TECHNICAL MEMORANDUM

Harris Teeter Fuel Center Traffic Impact Analysis Review

Date: May 5, 2021 Project #: 21905.013

Attachment ASite Plan Markup

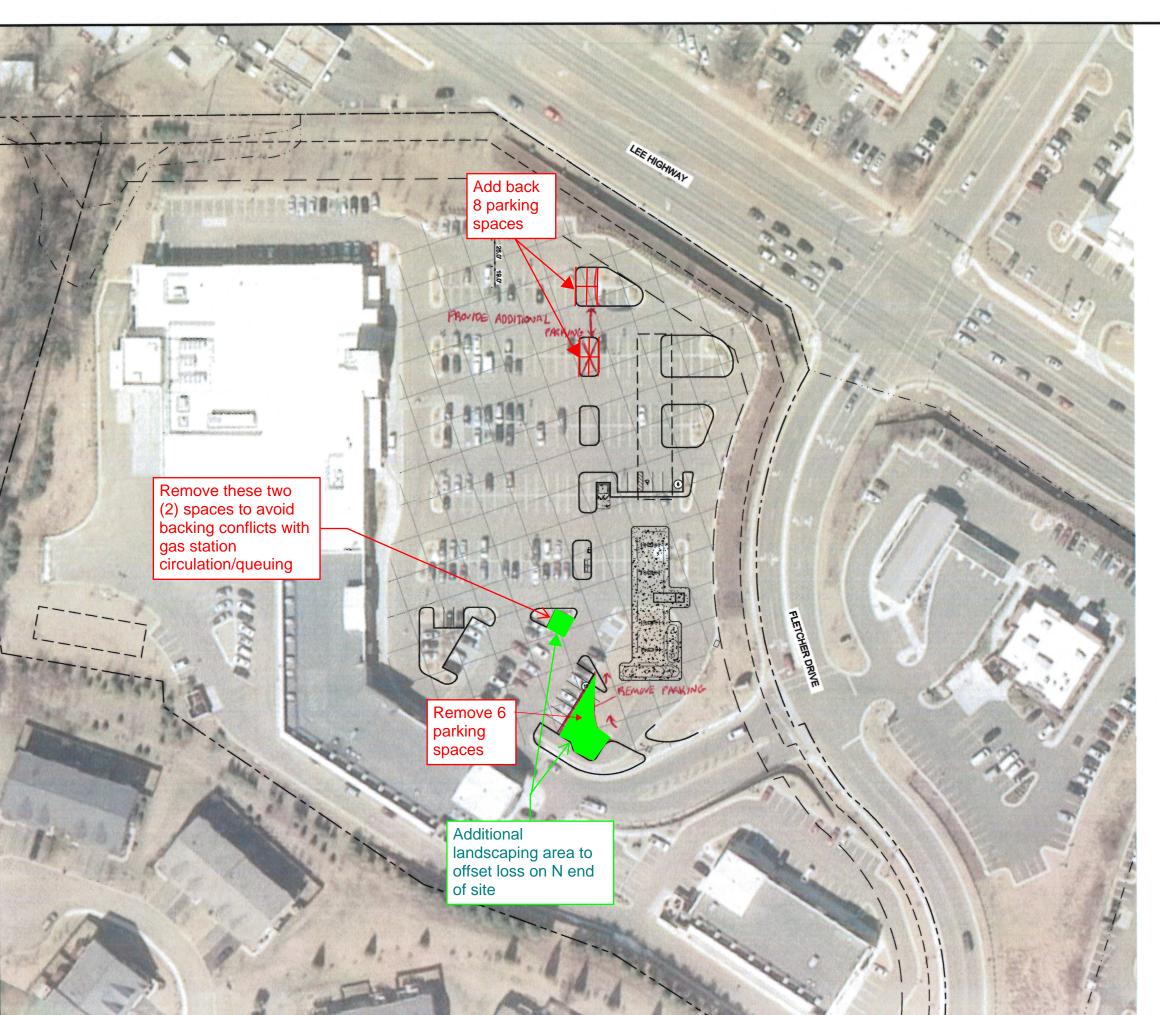
• From the site plan it is unclear where the fuel tanks will be located and/or how fuel trucks will access the site. We recommend providing truck turning movements/path for fuel truck access.

Town staff have noted issues with existing on-site circulation as a result of the site layout, which funnels all ingress and egress traffic through the drive aisles directly in front of the strip mall, leading to concerns that adding a fuel station could exacerbate these issues. Inbound vehicles must make a 180-degree right turn to continue circulating the parking areas away from the drive aisle in front of Harris Teeter. The proposed site plan will provide a short one-way inbound drive aisle to connect the access road with the fuel center area. We recommend the TIA report be expanded to address existing issues with on-site circulation and how these will be improved with the addition of the fuel center and new one-way inbound drive aisle.

The concept site plan notes the addition of the fuel center will result in a net loss of 66 parking spaces on-site. While the number of parking spaces provided will continue to meet the Town's minimum parking requirement, Town staff have raised concerns that existing parking demand favors the southern end of the site (nearer to the proposed fuel center) due to proximity to the single access road and the location of the strip mall. The image below was taken by Town staff during midday on a typical Thursday in March 2021 and documents the high parking demand in this area (directly in front of the optometrist / dental offices). We recommend the TIA report be expanded to address site circulation to other parking areas on the north side of the site that will become more heavily utilized after the proposed fuel center removes parking on the south side of the site. The attached site plan markup provides an alternative to improve inbound circulation to the fuel center and relocate parking to other areas of the site—this is intended to reduce underutilized parking near the fuel center and mitigate potential conflicts between the fuel center and parking areas, while retaining necessary landscaping minimums.
